1237 Gadsden Street

DESIGN/DEVELOPMENT REVIEW COMMISSION
DESIGN REVIEW DISTRICT
HISTORIC/REGULAR AGENDA
EVALUATION SHEET
Case #1

ADDRESS: 1237 Gadsden Street

NATURE OF REQUEST: Request for preliminary certification for the Bailey Bill and Certificate of Design Approval for exterior changes

1959--1237 Gadsden Street

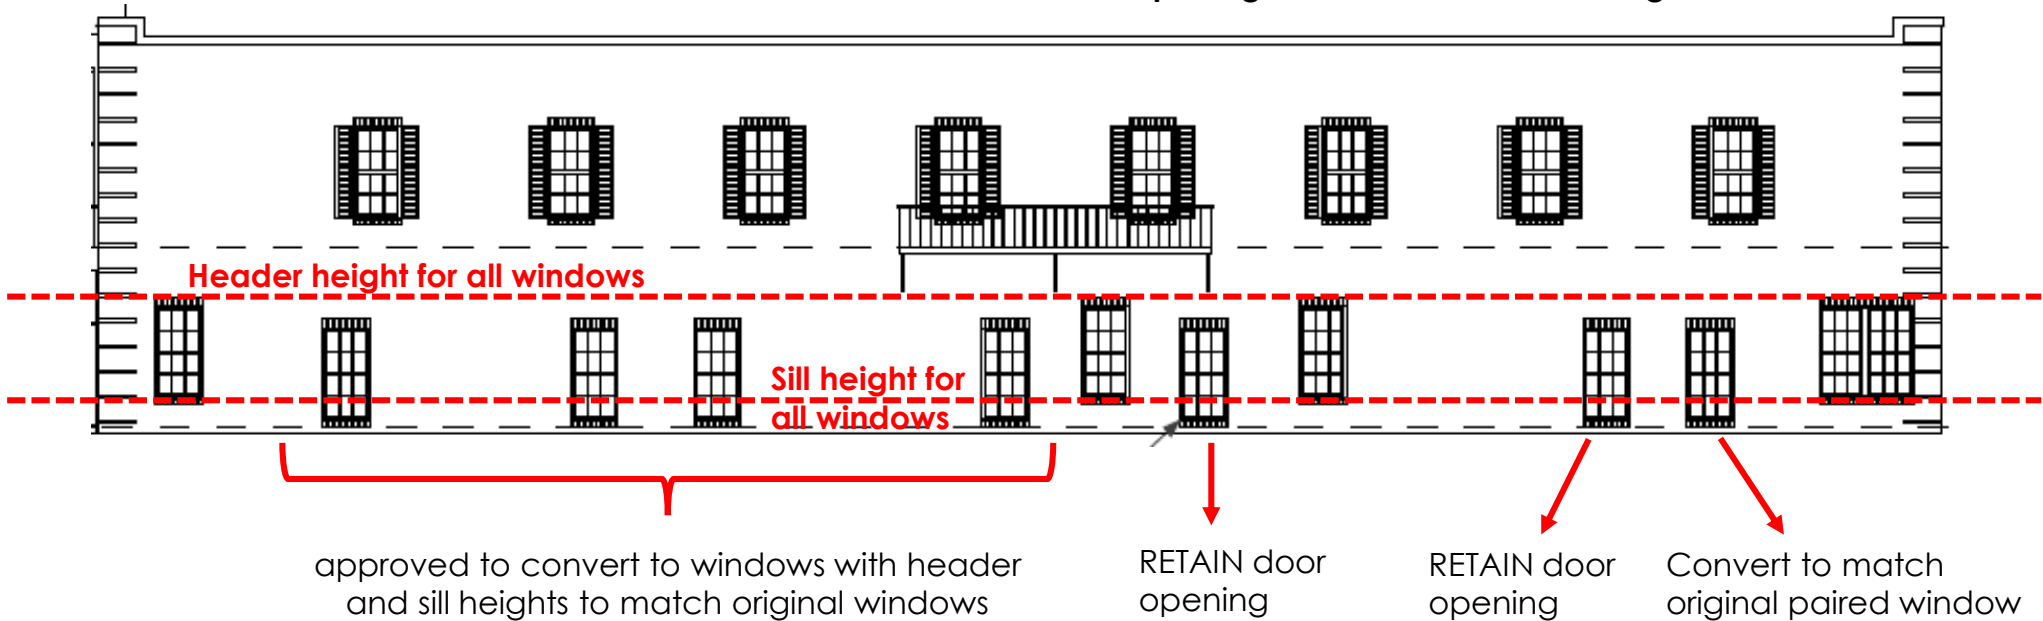
Location of original roll-up warehouse door

Location of original windows

Location of original roll-up warehouse door

Location of original single door and window- **RETAIN both openings**

Location of original single door and 2 double windows- **RETAIN door and re-establish missing double window**

Unless new evidence uncovers a different original configuration, staff recommends keeping the two door openings, as recorded on the historic photo. These non-original doors themselves could be secured or dry-walled over on the interior, if desired; likewise, there may be appropriate replacement doors with part glass which could be used as a reference to the originals but still be non-operational. The south elevation historically featured very few openings (aside from a freight opening which has been bricked in for many years) so an addition on this elevation will entail little loss of historic materials and is an appropriate location for it.

ARCHITECTURAL BSMNT

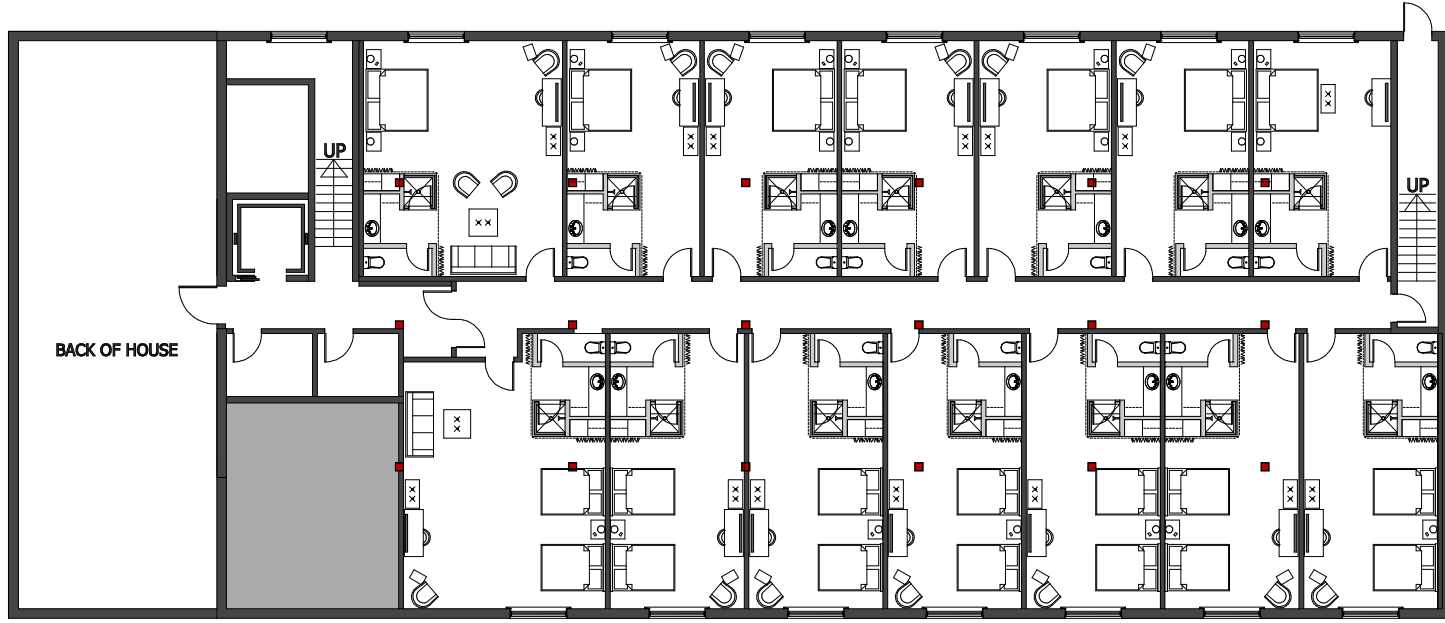
LIGHT WELLS WILL BE ADDED TO THE FRONT AND REAR ELEVATIONS TO BRING LIGHT INTO THE BASEMENT

ELEVATIONS

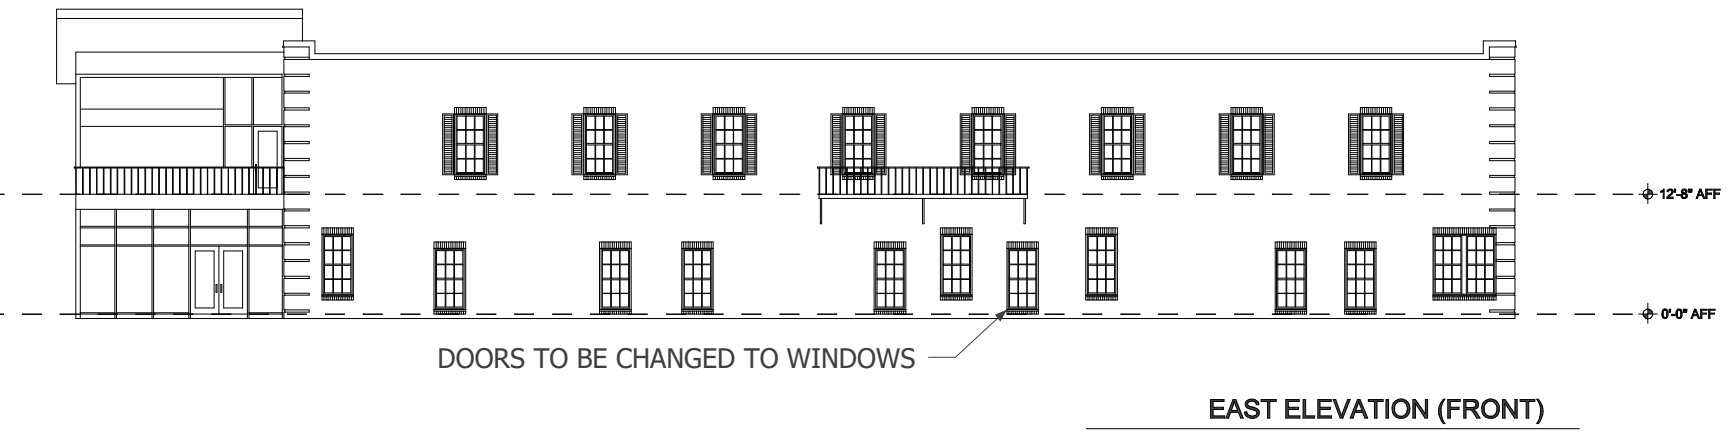
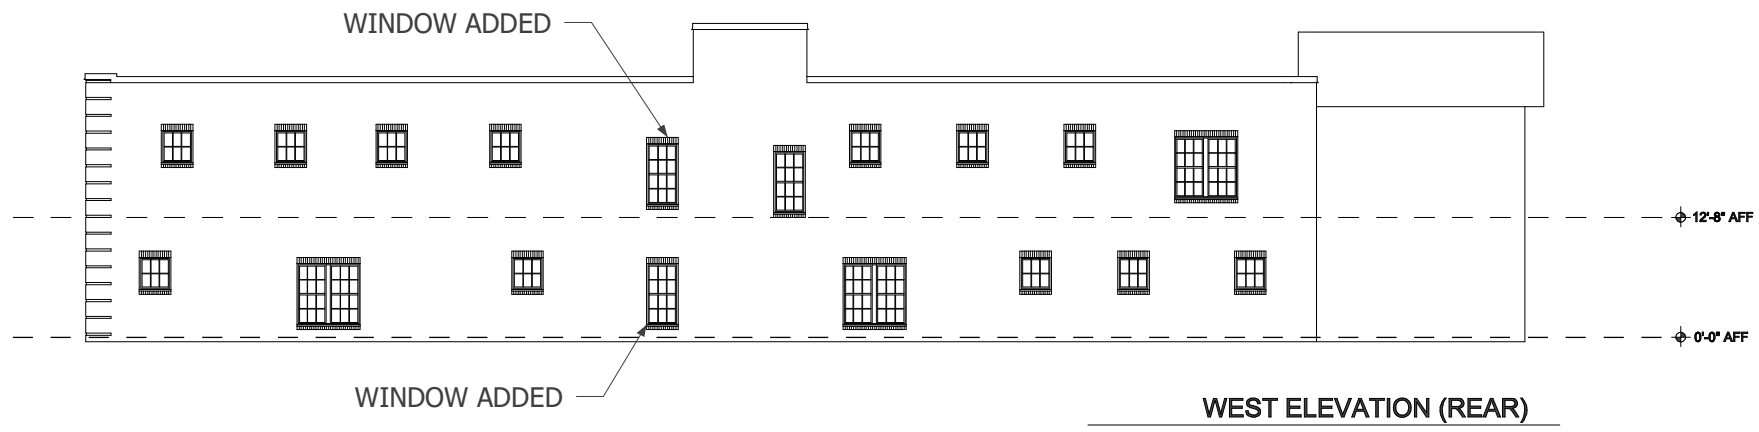
As stated earlier, several door openings are proposed to be turned into windows, several of which are approvable. However, the drawings show windows inserted full length into the extant door openings. For the openings approved to revert or turn into windows, the manner in which historic windows are detailed in the building should be reflected; for instance, there should be brick infill beneath the window and sills and headers which align with those of historic windows. While reflecting these basic elements, the windows, sills/headers may be detailed differently in subtle ways to differentiate them from original openings and windows.

2. *Retain the original rhythm and pattern of window openings.*
On the east elevation, historic windows still extant will remain. The owners are proposing to replace all of the doors with windows. Some of these doors were originally windows, so re-establishing an opening where there was one historically is approvable. However, these new openings should retain the rhythm and pattern of historic window openings by being sized and located to align properly with historic windows. Windows will need brick infill below and sills and headers, detailed slightly differently from the historic windows.
A few new windows are proposed on the west elevation but this elevation is not highly visible and is a secondary, if not tertiary, elevation. The proposed new windows fit with the rhythm of openings on this elevation.

- The retention of two door openings on the east elevation as recommended;
- That proposed window openings on the east elevation reflect the size, location, alignment, and detailing of historic window openings and windows there;
- The design and details of the addition and rooftop patio come back to DDRC for separate approval;
- All other details, including signage, be deferred to staff.
